**BEFORE THE NORTH CAROLINA UTILITIES COMMISSION
DOCKET NO E-100, SUB 207**

In the Matter of:	)	
2025 Biennial Consolidated Carbon Plan and	)	
Integrated Resource Plans of Duke Energy	)	DIRECT TESTIMONY OF
Carolinas, LLC, and Duke Energy Progress, LLC,	)	DEVI GLICK ON BEHALF
Pursuant to N.C.G.S. §§ 62-2(a)(3a), 62-110.1,	)	OF NORTH CAROLINA
62-110.9, and Commission Rule R8-60A	)	SUSTAINABLE ENERGY
	)	ASSOCIATION
	)

March 30, 2026

Figure 1. Duke Energy's projection of load growth in DEC in 2022, 2023, and 2025 CPIRPs

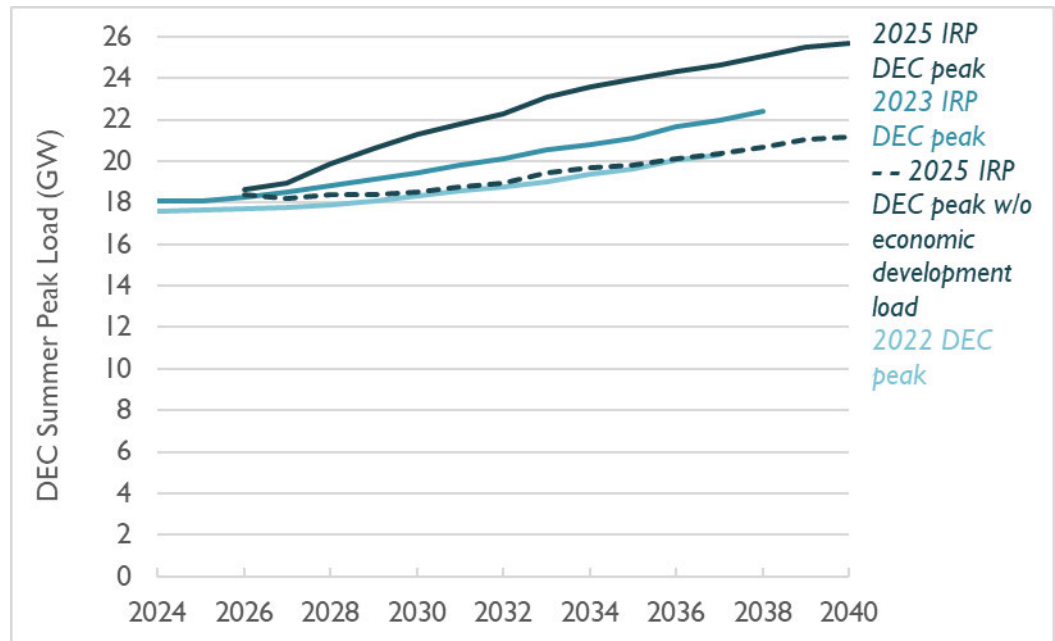
A The Companies currently project that DEC peak load will grow by an average compound annual growth rate ("CAGR") of 2.3 percent from 2026–2040, compared to 1.0 percent in the absence of economic development load (see Figure 1 below, with comparisons summarized in Table 2).¹⁹ Economic development increases peak load in DEC by 2.8 GW in 2030 (an increase of 15.1 percent relative

13
 14 DEC’s 2025 CPIRP load forecast with economic development load by 2037 is 17.7
 15 percent greater than forecasted in the 2022 Initial Carbon Plan and 10.8 percent
 16 greater than forecasted in the 2023 CPIRP.²³ DEP’s peak load forecast with
 17 economic development load by 2037 is 8.8 percent greater than projected in its
 18 2022 CPIRP and 2.1 percent greater than projected in the 2023 CPIRP.²⁴

Figure 2. Duke Energy's projection of load growth in DEP in the 2022, 2023, and 2025 CPIRPs

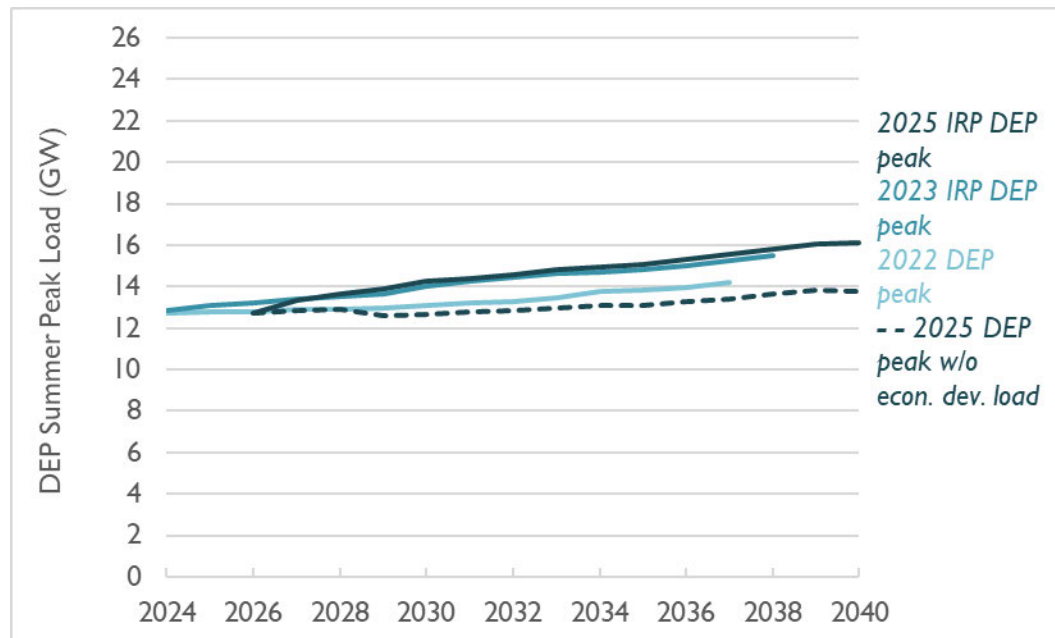
1 to the 2030 baseline peak load of 18.5 GW) and 4.5 GW by 2040 (an increase of
 2 21.2 percent relative to the 2040 baseline peak load of 21.2 GW).²⁰ Meanwhile, in
 3 DEP, Duke Energy projects peak load will grow by an average CAGR of 1.7
 4 percent from 2026–2040, compared to a 0.6 percent CAGR in the absence of load
 5 from economic development (see Figure 2, below, with comparisons summarized
 6 in Table 2).²¹ Load growth from economic development increases peak load in DEP
 7 by 1.5 GW in 2030 (an increase of 12.3 percent relative to 2030 baseline peak load
 8 of 12.7 GW) and 2.3 GW in 2040 (an increase of 16.8 percent relative to 2040
 9 baseline peak load of 13.8 GW). The Companies states that this load growth
 10 includes only “Advanced Development Projects,” which are economic
 11 development projects with executed ESAs, Letter Agreements (“LA”), or projects
 12 that have progressed to advanced stage discussions prior to signing an ESA or LA.²²

Figure 3. Reproduced Recommended Portfolio and NCSEA Alternative Portfolio generation by resource type

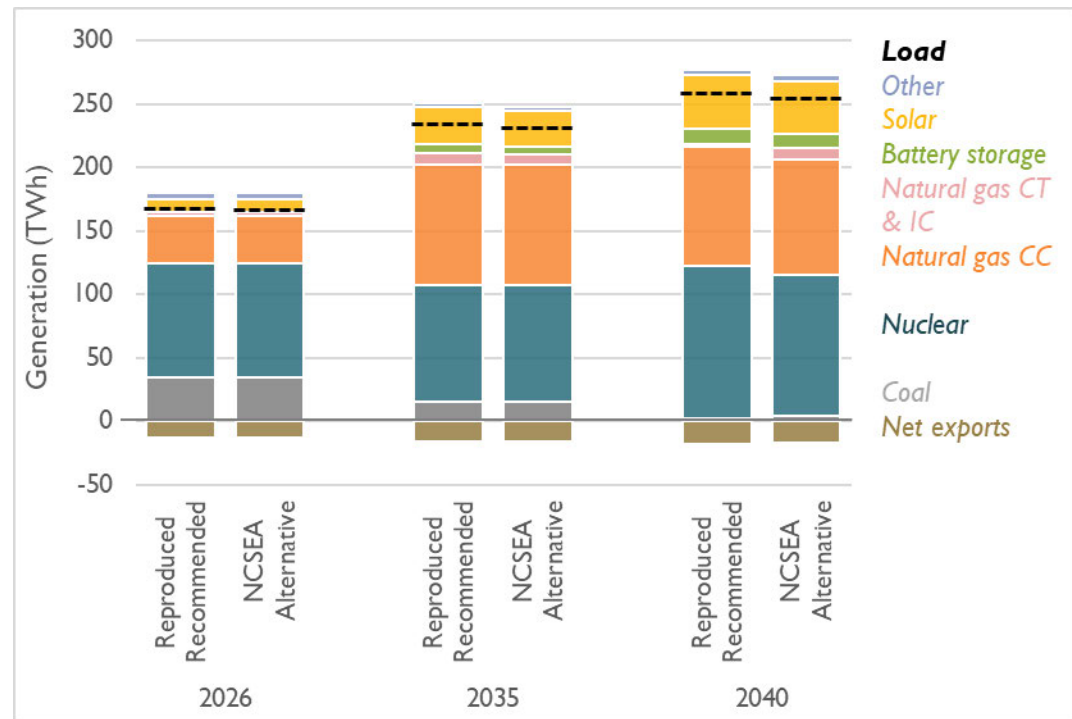
21 A Figure 3 below shows the generation results of the Reproduced Recommended
22 Portfolio and the NCSEA Alternative Portfolio. Although both portfolios have the
23 same quantity of coal capacity, the amount of generation from coal is lower than

the Reproduced Recommended Portfolio in the near term from 2026–2029. In addition, natural gas combined cycle capacity in the Reproduced Recommended Portfolio and the NCSEA Alternative Portfolio are the same until 2031, but generation is lower from natural gas combined cycle capacity in the NCSEA Alternative Portfolio from 2026–2031 as a result of load reduction from additional energy efficiency and additional demand response deployment compared to the Reproduced Recommended Portfolio.

Figure 4. Carbon dioxide emissions in scenarios modeled by Synapse

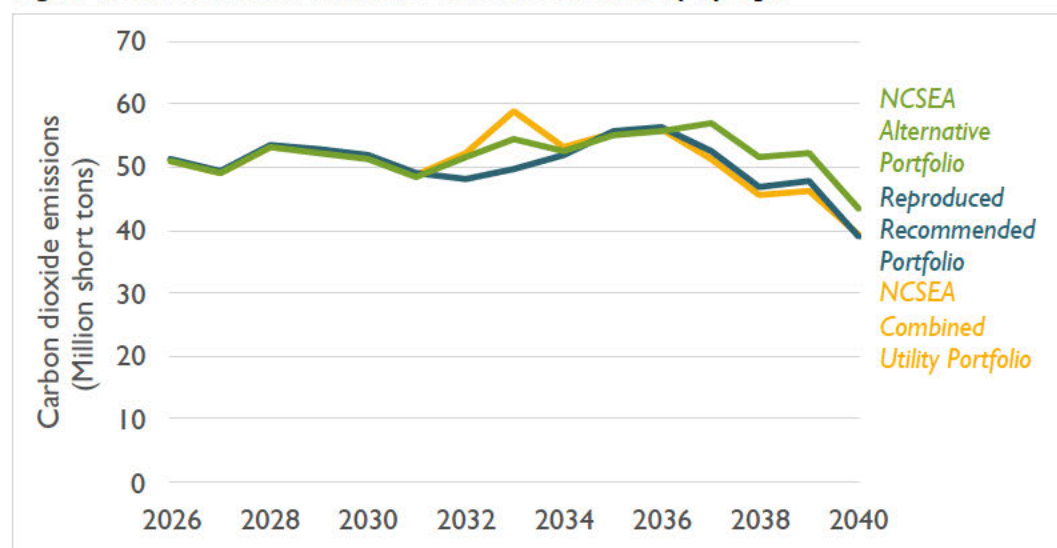
the NCSEA Combined Utility Portfolio emits, on average, 0.6 million short tons of carbon dioxide more than the Reproduced Recommended Portfolio annually. Total carbon dioxide emissions over the study period (2026–2040) are 3 percent lower in the Reproduced Recommended Portfolio compared to the NCSEA Alternative Portfolio and 1 percent lower compared to the NCSEA Combined Utility Portfolio. This difference in emissions is largely caused by the NCSEA Alternative Portfolio and NCSEA Combined Utility Portfolio deferring the addition of gas-fired generation and relying more on existing resources (*i.e.*, coal). I also note that for all portfolios, total carbon dioxide emissions could be greater than estimated here if carbon dioxide emissions related to ELNG facilities owned by Duke Energy are taken into account—these facilities could produce emissions or leak emissions in quantities not accounted for in this analysis.
